Design Review Subcommittee (DRSC)

Meeting Date: February 26, 2020

SUBJECT: **Cultural Heritage Permit 19-130/ Variance 19-131/ SPP 19-217, 1602 N. El Camino Real Mixed Use,** a request to consider a renovation and addition of two stories to an existing one-story commercial building, resulting in a first floor commercial unit with a two-story residence above, including a variance to exceed maximum lot coverage at 1602 N. El Camino Real in the Mixed Use 2 zoning district and the Architectural, Visitor Serving Commercial District, and Coastal Zone overlays.

PROPOSED 1ST. FLOOR PLAN

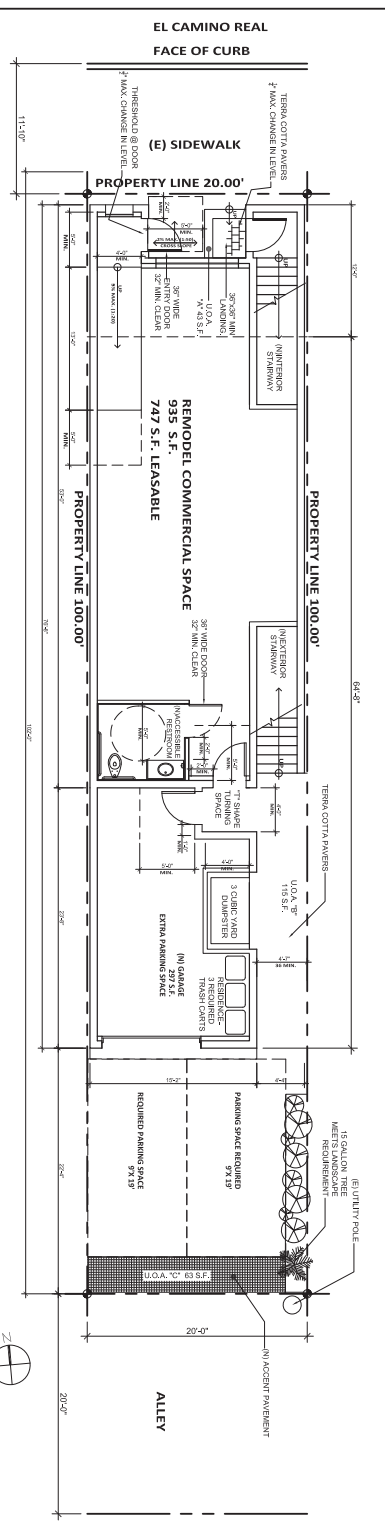
2. Request a variance to allow tandem parking for the residence, consistent with the tandem parking allowance for duplexes on narrow lots. Eliminate the second outdoor parking space. Staff believes the findings for a variance could be made in this instance because the width of the lot creates a special circumstance difficult to accommodate parking facilities that comply with the SCMC. Additionally this issue could prevent the property owner from developing a mixed use project on this site, which is a property right possessed by other property in the same vicinity and zone. This reconfiguration would increase conformity with several General Plan Policies and Design Guidelines and improve the functionality of the design as follows:

- a. The space gained could be used to provide a “usable open space” area at the ground level.
 - b. The space could be used to incorporate additional landscape area to meet minimum landscape requirements.

- c. Currently, there would be no way to get the commercial dumpster out to the alley if the residential parking spaces are both in use. The trash enclosure could be moved to the back alley, increasing functionality of the site plan.

WEST ELEVATION

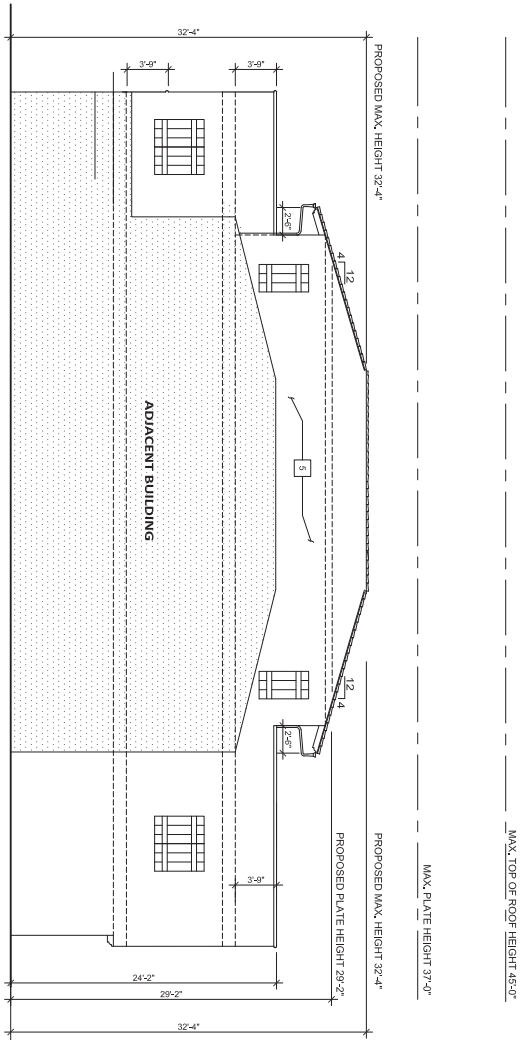
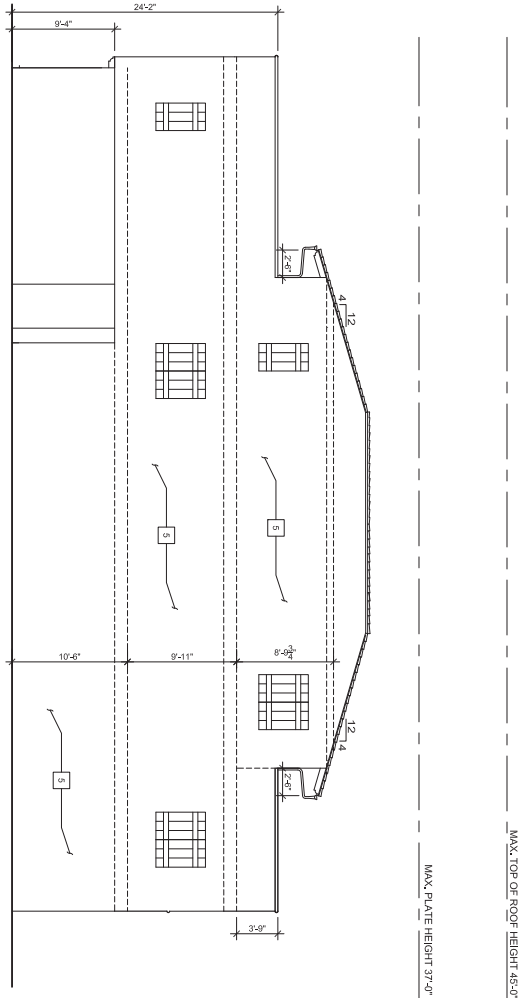
The primary design guideline inconsistencies are the long, unrelieved walls at each side. The property is constrained by the narrow lot width, limiting what the applicants can do to mitigate this issue and still be able to develop a three-story building. For example, window openings are not permitted at property line and plane changes would result in a building narrower than 20 feet, an already narrow building. In response to staff comments, the applicant did incorporate some faux shutters to help add interest. Staff recommends the applicant give further consideration to remedies for the long, unrelieved wall planes at the sides of the building.

3. Incorporate additional design modifications meet General Plan policies and Design Guidelines related to unrelieved wall planes, articulating building forms, dividing mass into smaller scale components, and creating strong patterns of shade and shadow.

STREET ELEVATION-NORTH

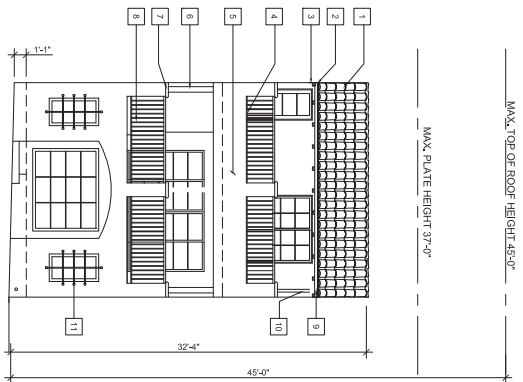
1. Modify the front entry opening. The proportions of the segmental arch are not correct for traditional SCR style. Because the first floor does not have the height needed to expand the arch height, staff recommends a rectangular opening with decorative trim or corbels at the top corners.

11. <i>Henry Lenny Design Guidelines, Arches and Arcades.</i> Arched openings should follow the classical proportions of an arch as pictured in the Design Guidelines.	Not Consistent. The segmental arch height should be in correct proportion to the width, which may not be achievable with the width necessary for the entry.
